NOTICE OF DECISION

DECISION OF THE HEARINGS OFFICER

**CONDITIONAL USE / CLASS 3 SITE PLAN REVIEW / CLASS 2 DRIVEWAY
APPROACH PERMIT / CLASS 1 DESIGN REVIEW CASE NO.: SPR-DAP-DR20-
06**

SUMMARY: Development of a new two building apartment complex with 24 dwelling units.

SITE PLAN

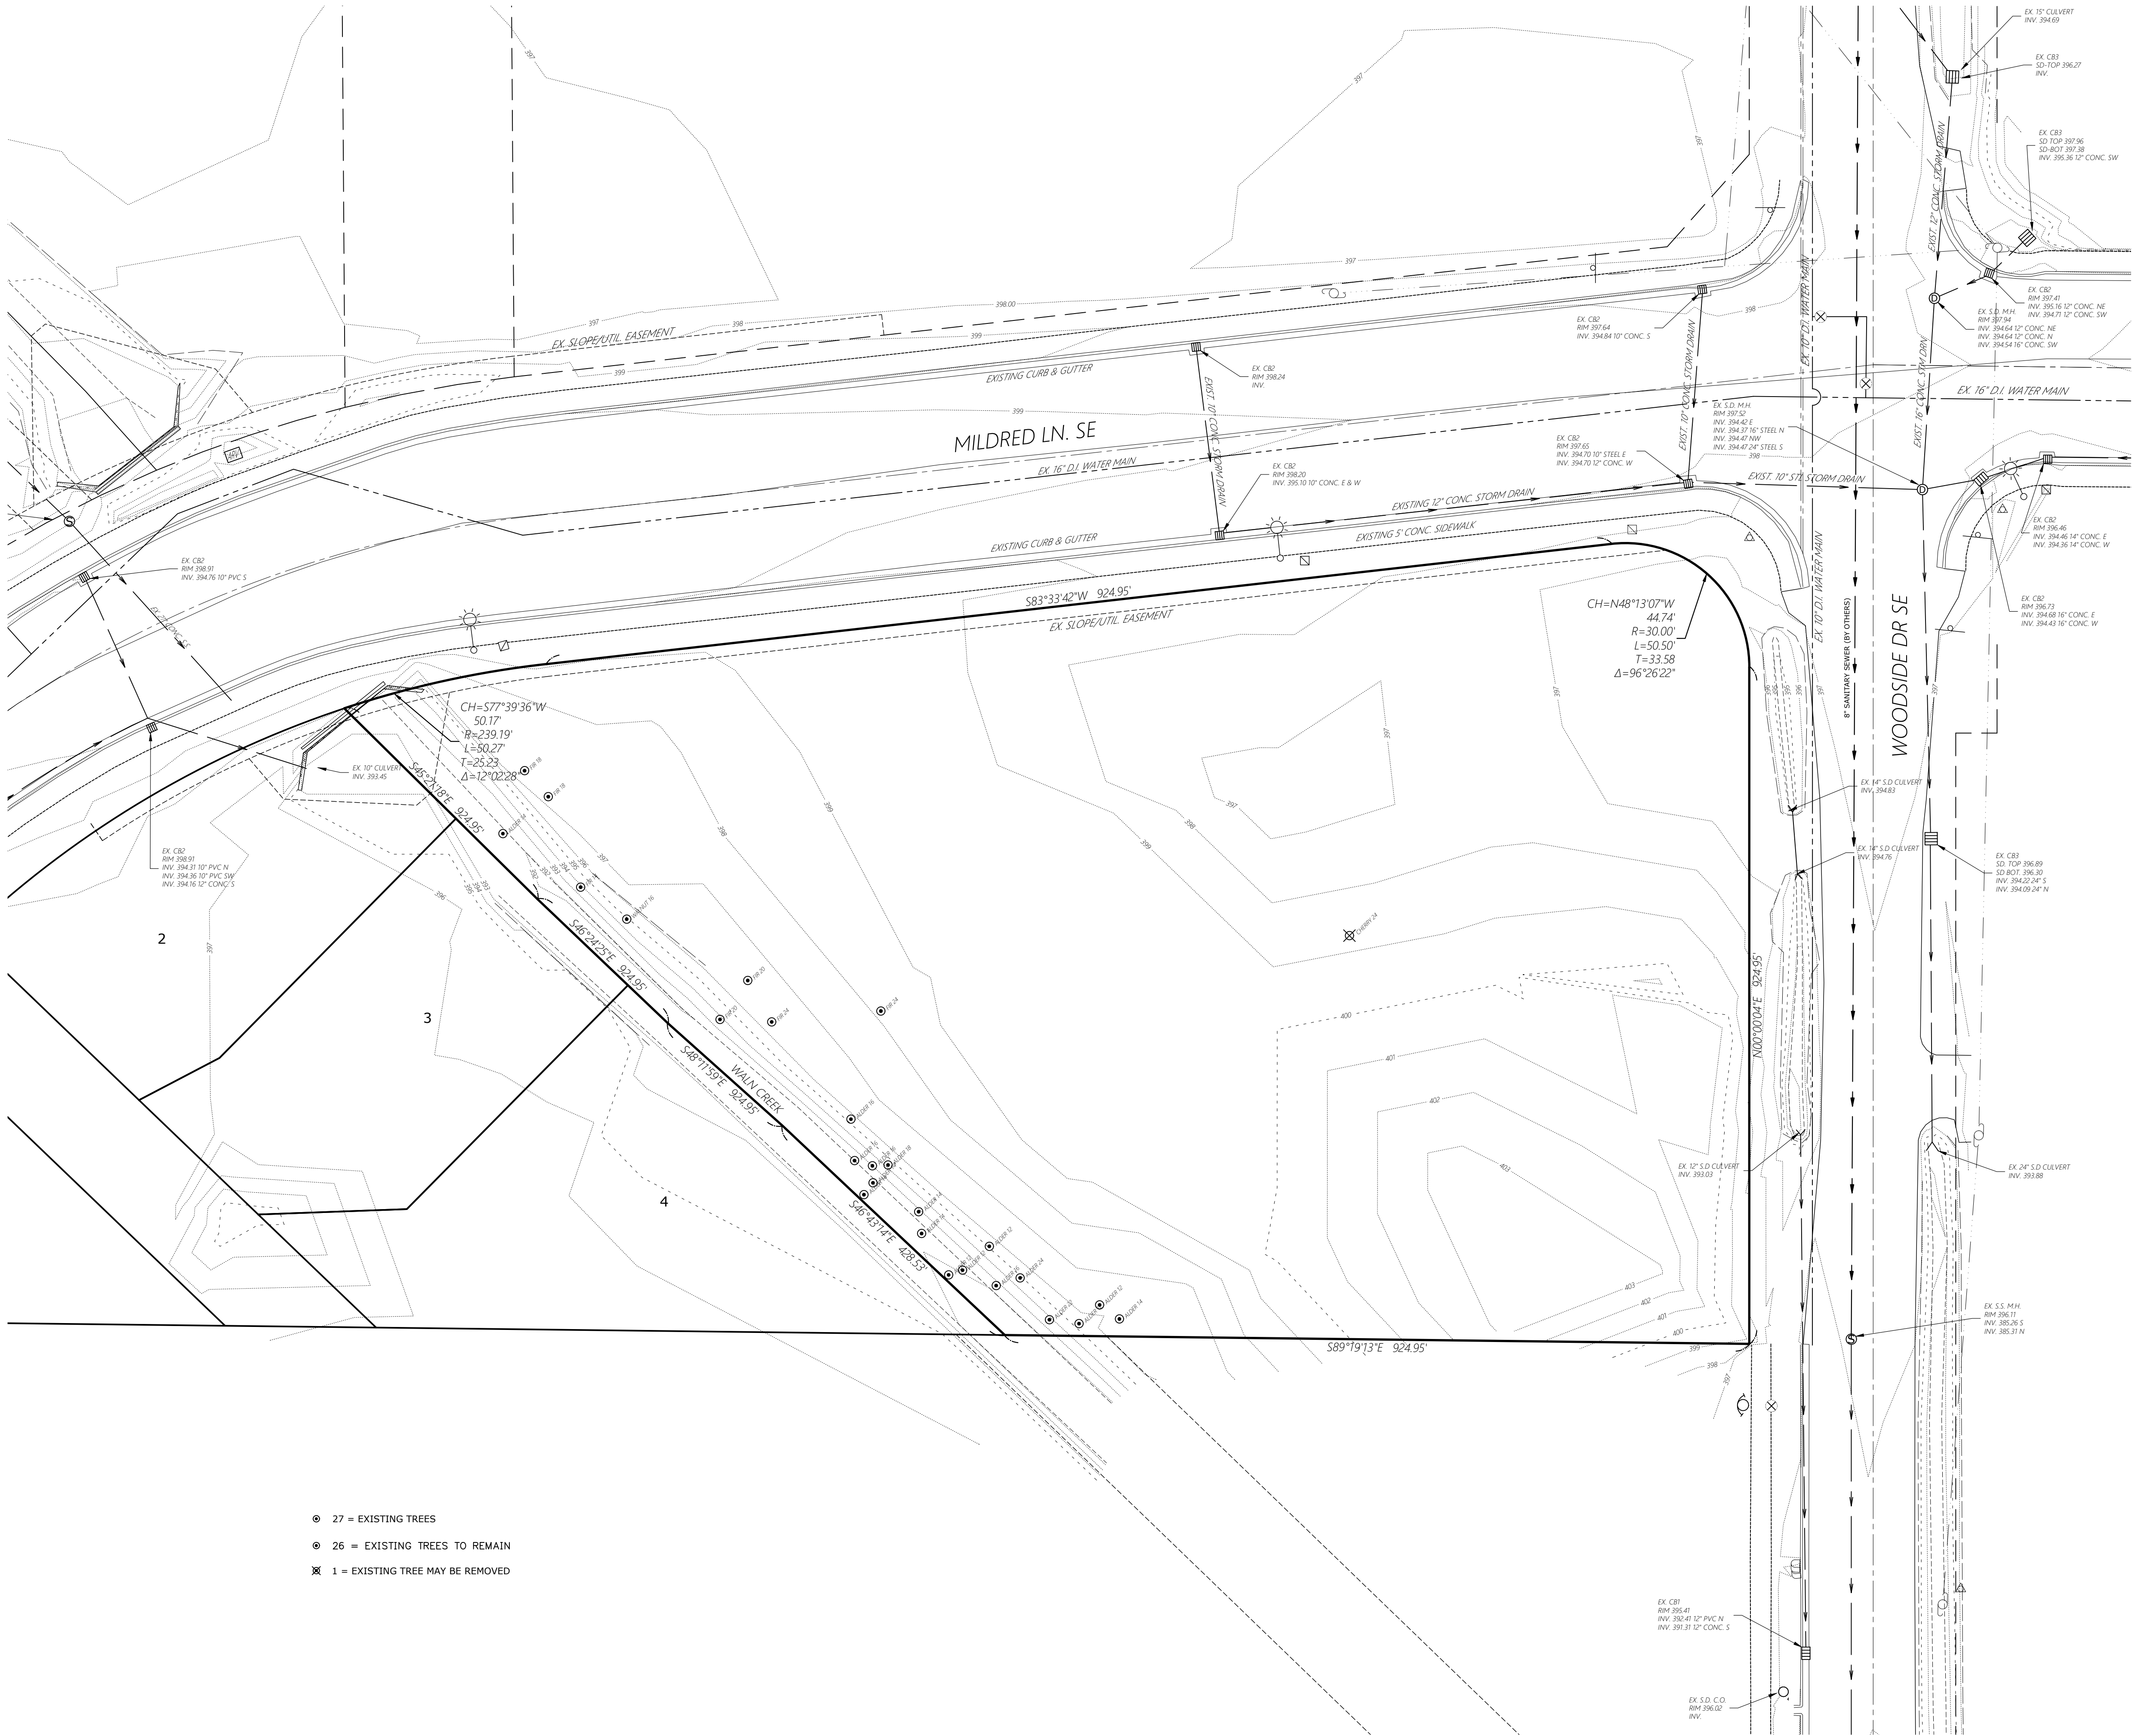
Finding: The Hearings Officer notes that the applicant's proposed site plan does not match the proposed landscape plan. The proposed landscape plan eliminates one off-street parking space from the site plan, and in its place is a landscape island as required by SRC Chapter 702. To ensure that this standard is met, the Hearings Officer imposes the following condition of approval:

- Condition 5:** Prior to building permit issuance, the proposed site plan shall be updated to include the additional landscape island shown on the landscape plans.
